47-50 The Esplanade - Ettalong Beach

*Section 4.55(1A)
Modification Assessment
(MP 09_0121 MOD 5)*

April 2019

Figure 9 | Level 3 floor plan with revisions to original application shown in green (Source: RtS)

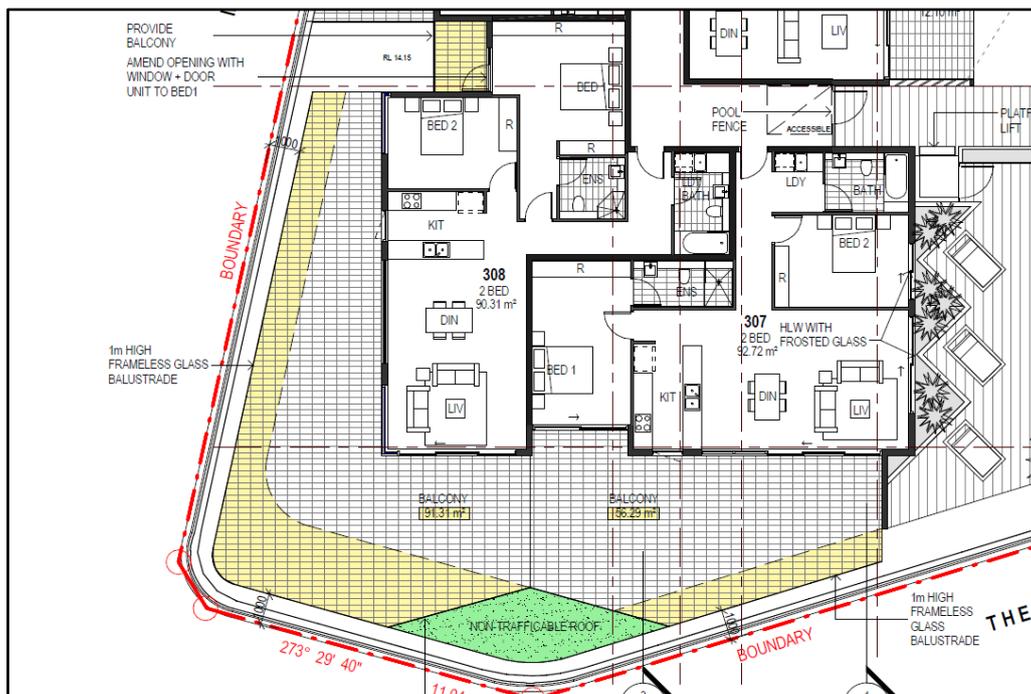
- making sections of the balconies on levels 3 and 5 for apartments 307, 308, 506 and 507 non-trafficable
- reducing the extent of privacy screens on levels 3 and 5
- proposing that the new glass balustrades on levels 3 and 5 are to be frameless
- removing the proposed changes to the rooftop.

Figure 15: Level 5: Original proposed modification (left) and revised proposed modification after RtS (right).

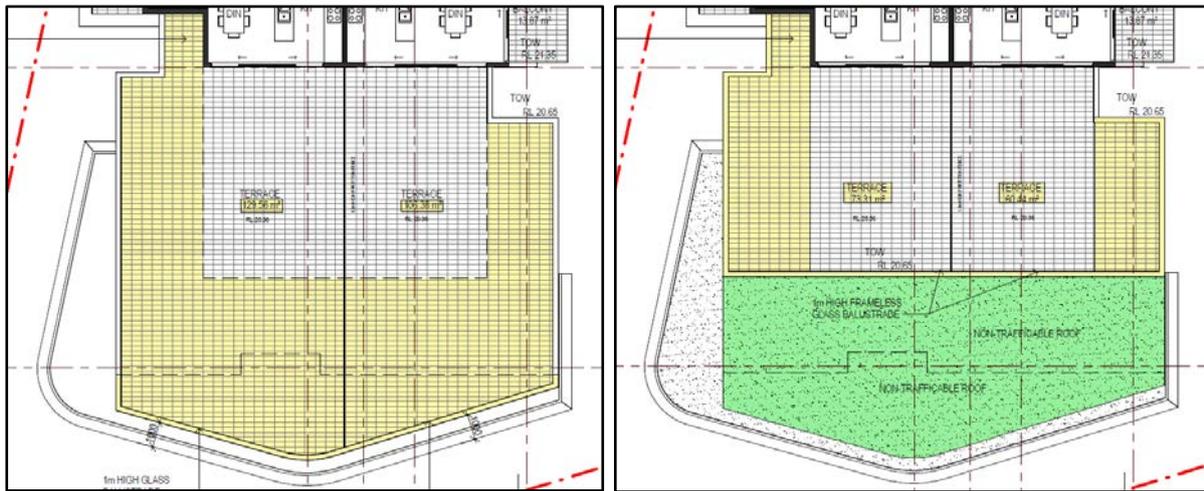
In response, the Applicant revised the application in the RtS to remove the proposed rooftop terrace, reduce the extent of the level 3 and 5 balcony extensions and privacy screens. The Applicant also amended the design of the balustrades from glass to frameless glass for levels 3 and 5. A comparison of the original and revised proposed modifications is shown in **Figures 14** and **15**.

The Department also notes the proposed frameless glass balustrades for levels 3 and 5 will minimise the visual impacts of the balustrades and ensure through balcony views. Based on the above assessment, the Department is satisfied the proposal is reasonable and the additional view loss impacts are negligible.

Figure 16: Aerial photograph showing view points from the Mantra building (Base source: Nearmap)

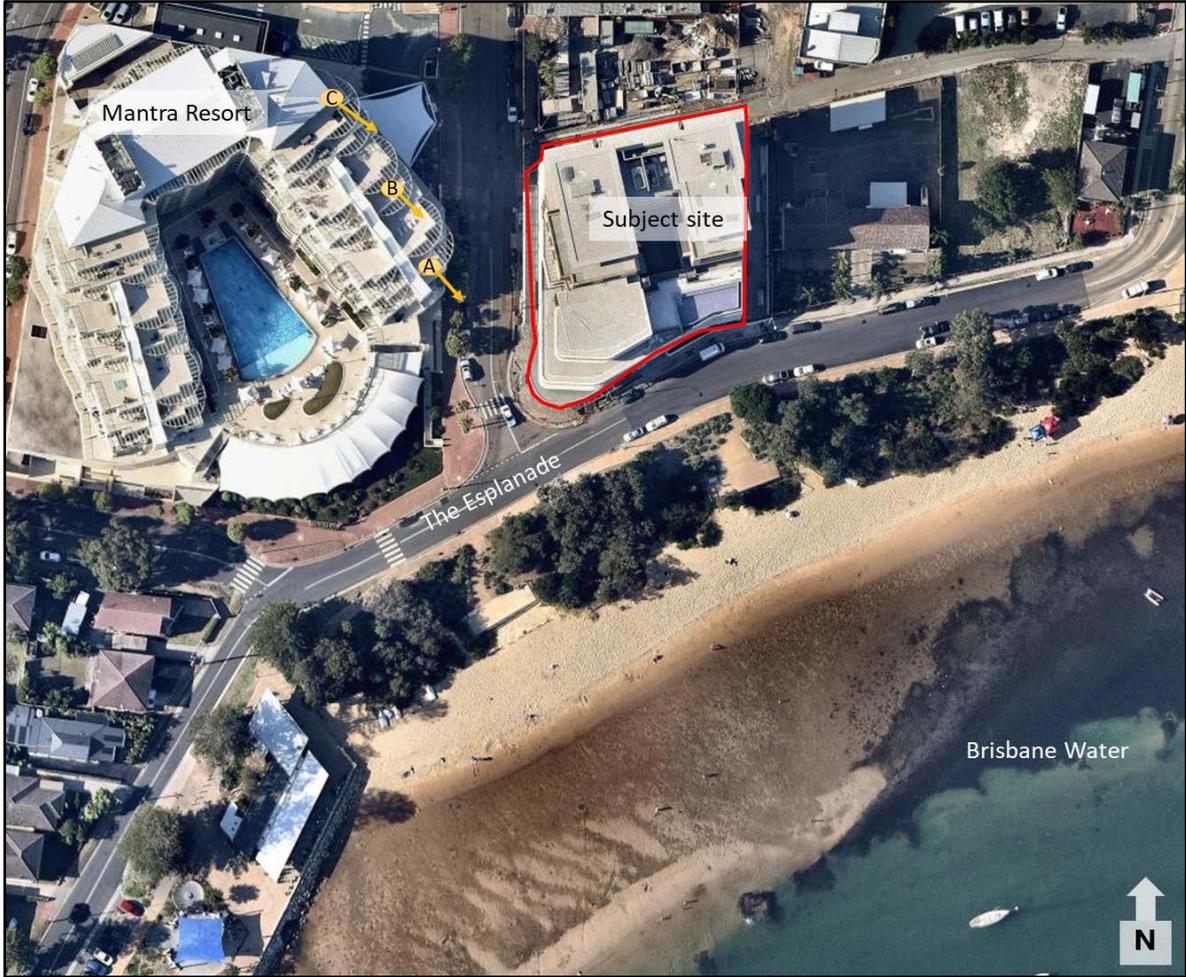
Step 1: The Mantra is a nine-storey mixed use building configured in a U-shape around the pool area. The apartments have a predominately south-east aspect with existing views to the south, south-west and south-east towards the Brisbane Water and surrounding district (**Figure 16**). The proposed balconies would interrupt some water views towards the south east. All other views would be retained.

Step 2: The views most affected by the proposal are generally gained from living areas and balconies of apartments along the eastern elevation of the Mantra. The view loss impacts to some of these apartments are shown in **Figures 17 to 19**. These images have been marked up to show the extent of the approved balconies (green) and the indicative extent of the proposed balconies (red). Note: the balustrades in the photographs are not expanding to the length shown in these pictures. The balustrades have since been removed (see **Figure 16**).

Step 3: The Department considers the overall change in views compared to the original approval is negligible. At all locations (A, B and C), the overall appearance of the view remains similar. Views of the water and district are retained, and the marginal loss of water and sky views as a result of the proposal would not impact on the overall quality of the view.

Figure 20: Revised Level 6 floor plans showing changes to the terraces
(Source: Applicant's revised plans dated 19.2.19)

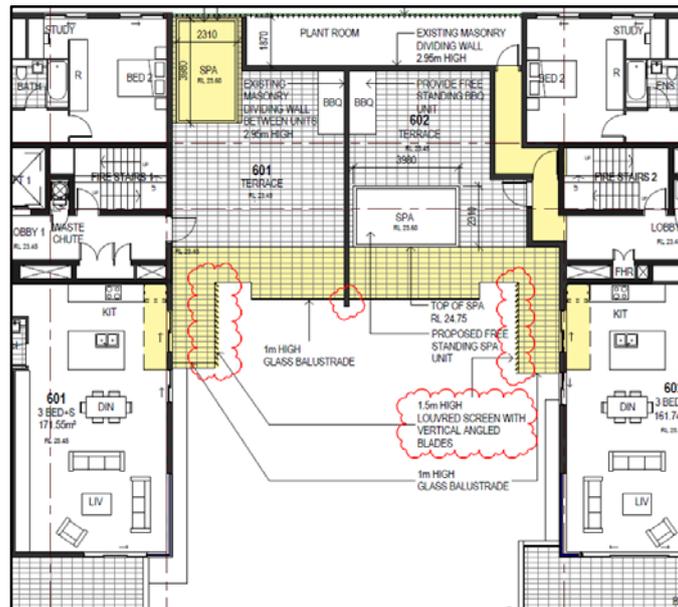
Bulk and Scale	<ul style="list-style-type: none"> Two submissions raised the issue of bulk and scale of the development. The Department notes the proposed modifications would be largely contained within the approved building envelope and the development would retain a tiered and stepped appearance. As such, the Department is satisfied the proposal would not result in any significant changes to the approved bulk and scale of the building. 	<ul style="list-style-type: none"> No additional conditions or amendments necessary.
Apartment Design Guide (ADG)	<ul style="list-style-type: none"> The proposed balconies and extensions are generally compliant with the ADG. The Department considers the new and modified balconies will provide improved amenity to the apartments by further increasing private open space levels, maximizing views towards Brisbane Water and increasing passive surveillance opportunities. Despite these improvements, the Department raised concern about privacy between apartments 601 and 602. The proposal seeks to extend the balconies and replace the approved privacy screening with glass balustrades. These amendments are sought to improve the amenity of the apartments by providing the terraces with water views. In response, the Applicant provided amended plans that add 1.5m high louvred screens with vertical angled blades to the balconies and extend the approved masonry dividing wall between the terraces as shown in Figures 20 and 21. 	<ul style="list-style-type: none"> No additional conditions or amendments necessary.

- The Department considers the proposal is acceptable as:
 - overlooking impacts have been minimised through the Applicant's revised plans which now include 1.5m high louvre screens along the balconies and an extended dividing wall between the terraces
 - the amenity of these apartments will be improved by views towards Brisbane Waters
 - the apartments as approved were designed to minimise overlooking by orientating living areas and the primary balconies to the south towards the water.
- In this instance, the Department considers that the reduction in internal privacy is offset by the iconic water views, providing an acceptable level of residential amenity.
